SUBJECT: Thomas Jefferson Park and North Yard Sewer Modifications
Contractor: J B Coxwell Contracting, Inc.
Contract No: 6533-51

CITY OF JACKSONVILLE
 DEPARTMENT OF PUBLIC WORKS
 ENGINEERING DIVISION
 CONSTRUCTION CHANGE ORDER

Change Order No. One (1) Date May 5, 2014

Description of Project Thomas Jefferson Park and North Yard Sewer Modifications

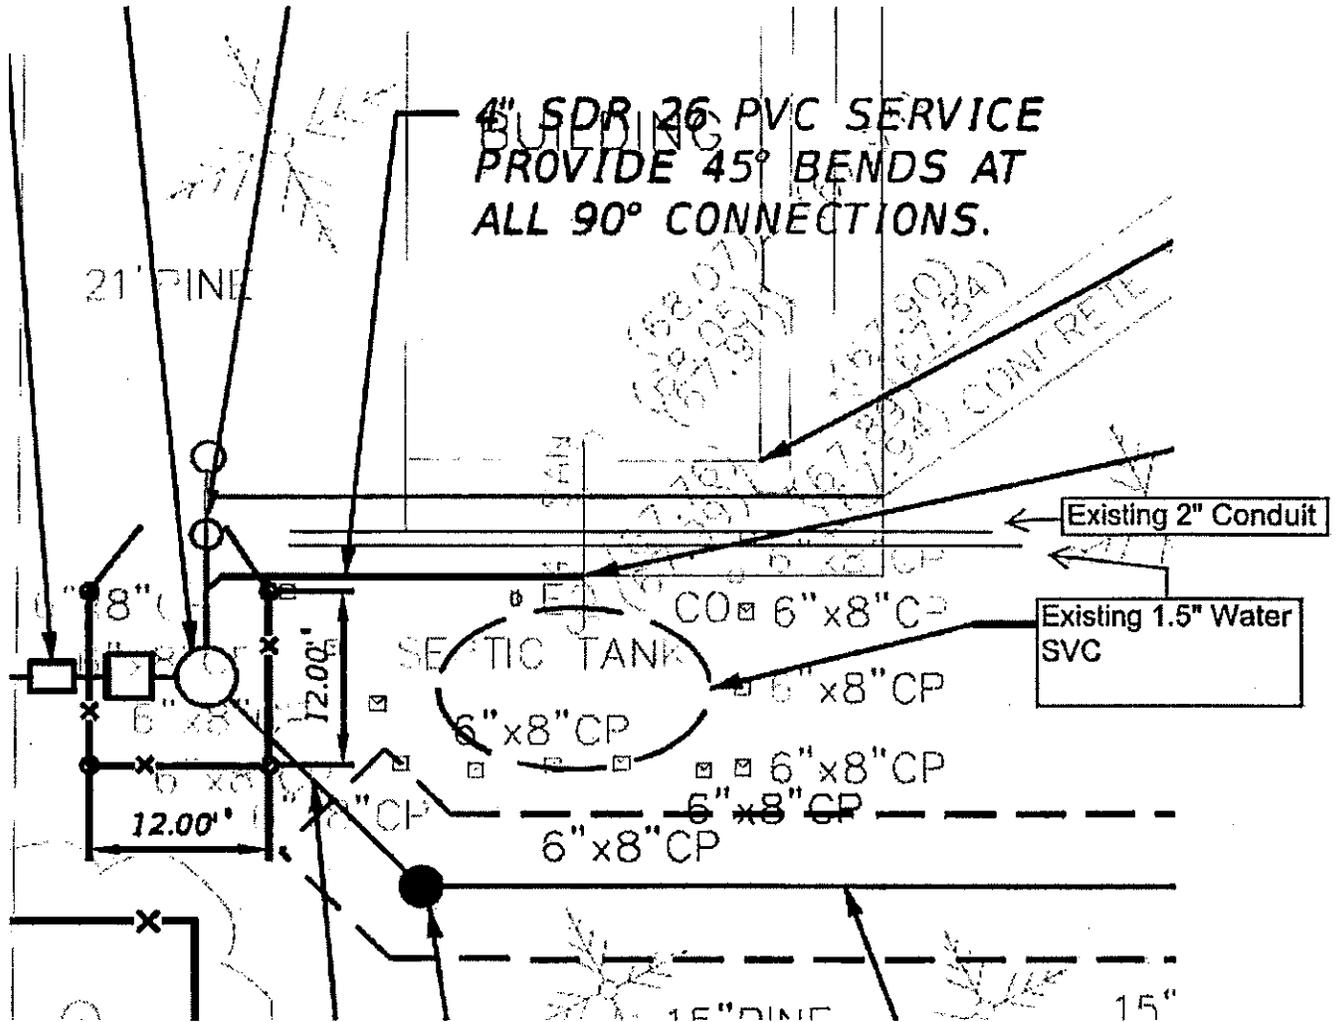
Add alternate to replace adjacent broken sidewalk \$ 1,309.79 (see attached photos)

So the photos depicting broken sidewalk were not part of the TJ ADA sidewalk project Callaway recently completed because the City knew they get replaced in this project? They were held out knowing they would get damaged with your project?

Understood, perfect sense. Add alt for sidewalks appvd also.

Attachment A

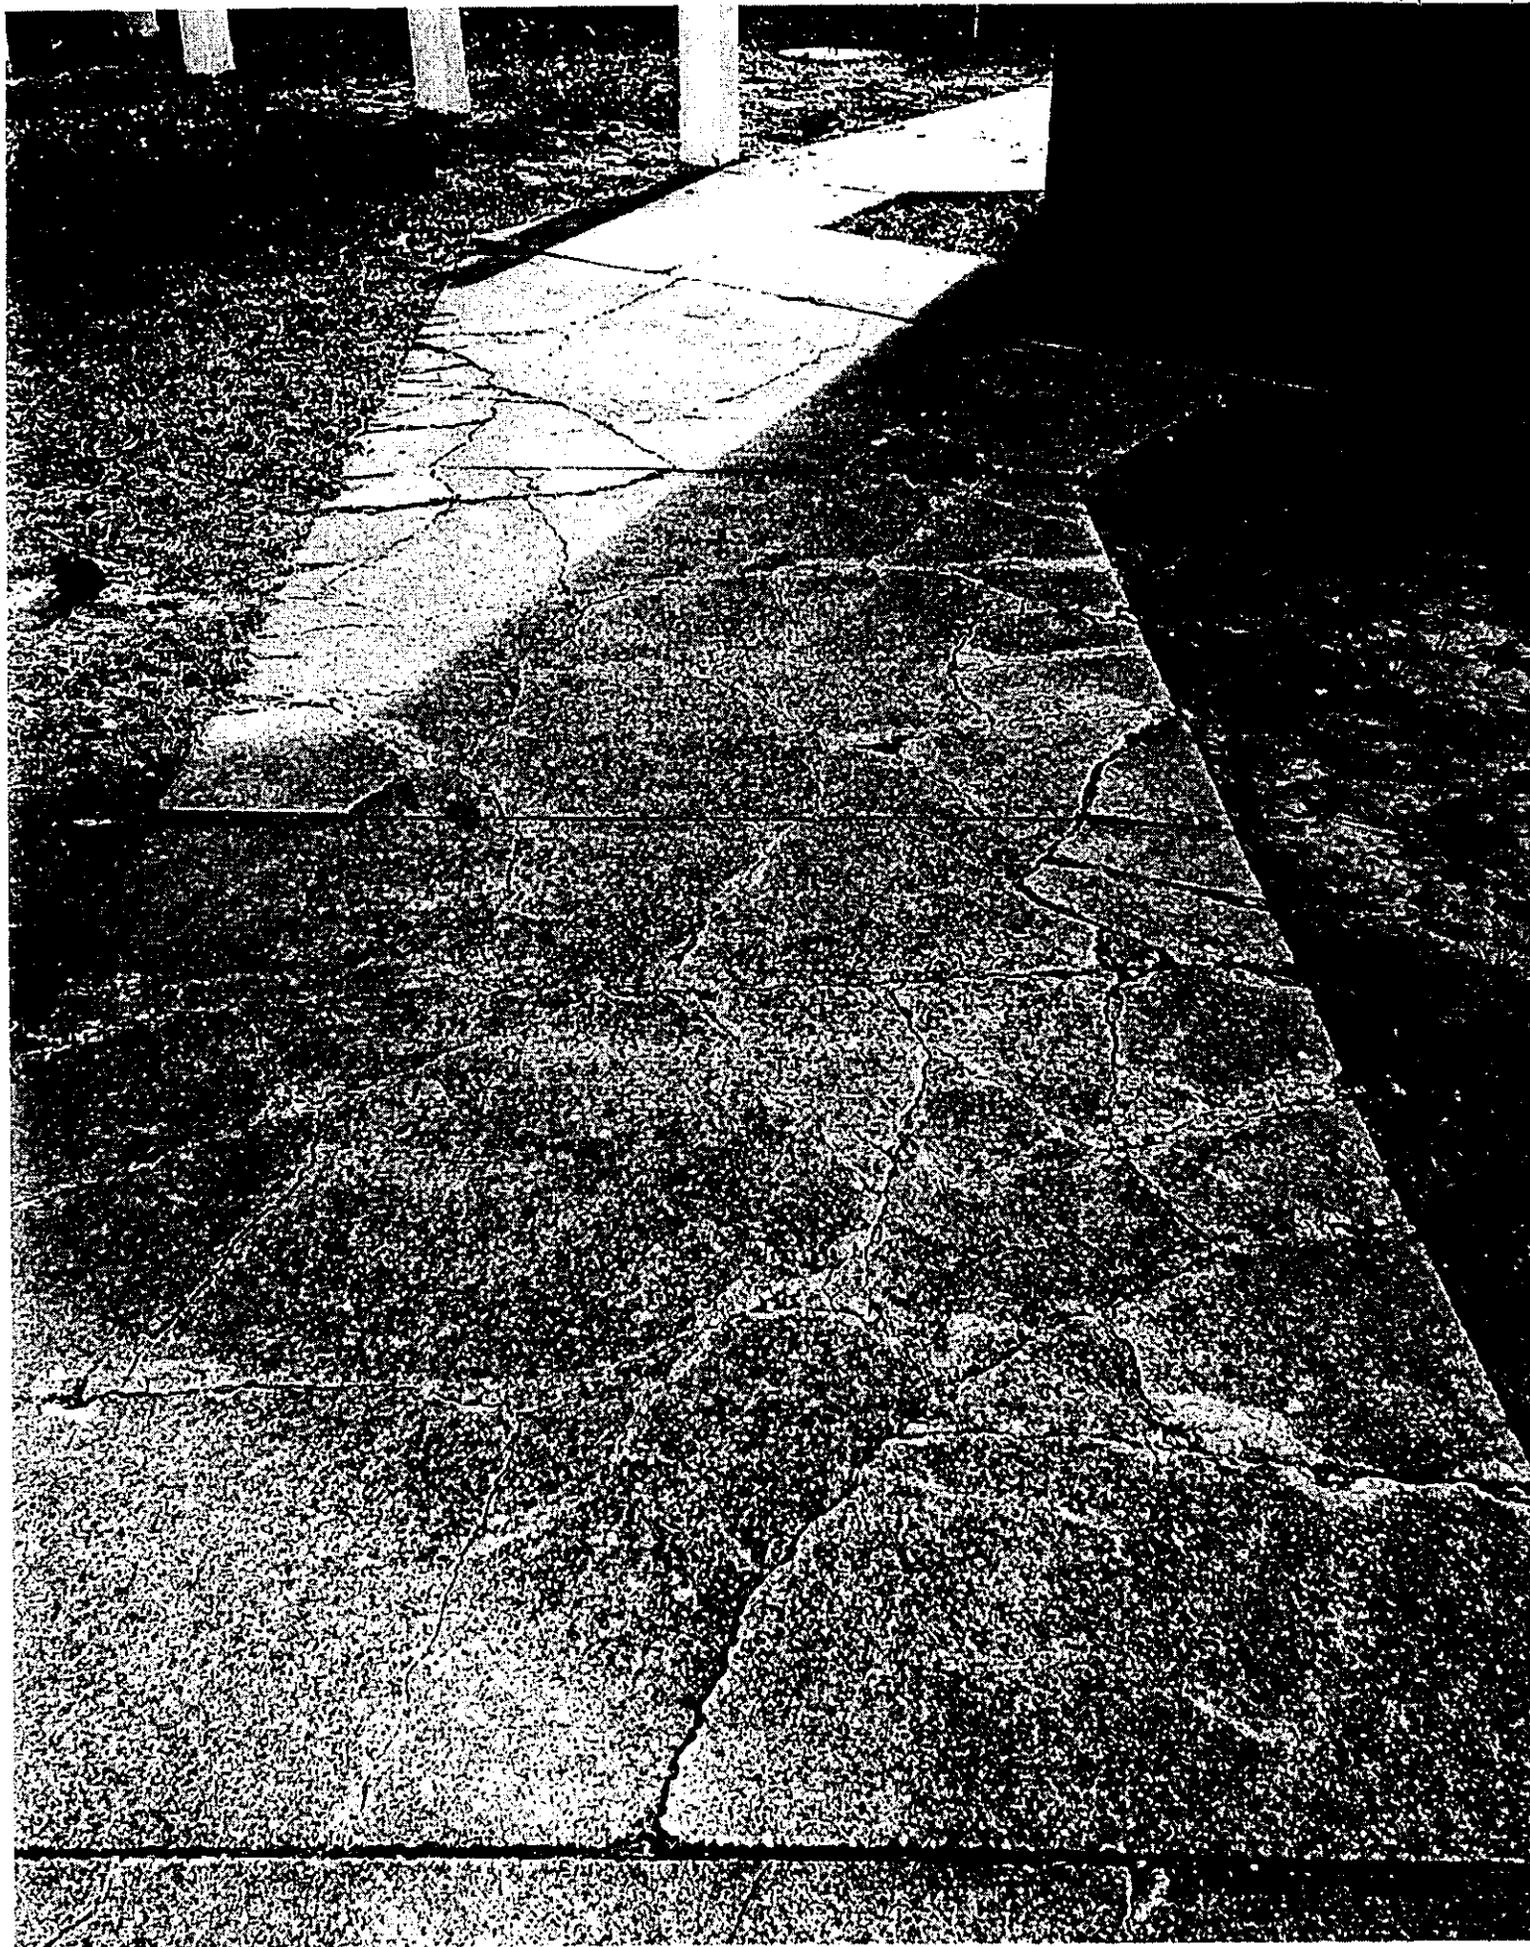
There are unforeseen existing utilities found in conflict with the proposed water and sewer connections. After consulting with Hanson Professional Services, Inc. on-site it was agreed we should propose a revised route and provide associated additional cost for review. As such J. B. Coxwell Contracting, Inc. (JBCCI) provides the following lump sum price proposal of \$ 2,945.80 to modify the proposed utility connections per Attachment A. The additional work will include but is not limited to:

22.78 SY of 4" Concrete Sidewalk
Two 4"x4" T-wye
One clean out assembly
One 3x4 reducer
One 1.5" 90 degree bend

The proposed lift station water and sewer connections will not work due to unforeseen existing utilities. Attached please find our proposed configuration and the additional cost to complete the field modification.

Appvd as submitted

Tom – I met Coxwell at the site and saw the conflicts they discussed in the letter. The only potential route for the sewer would be under the sidewalk, which would involve the work they listed. If you need to discuss this more, please don't hesitate to give me a call. Thank you.
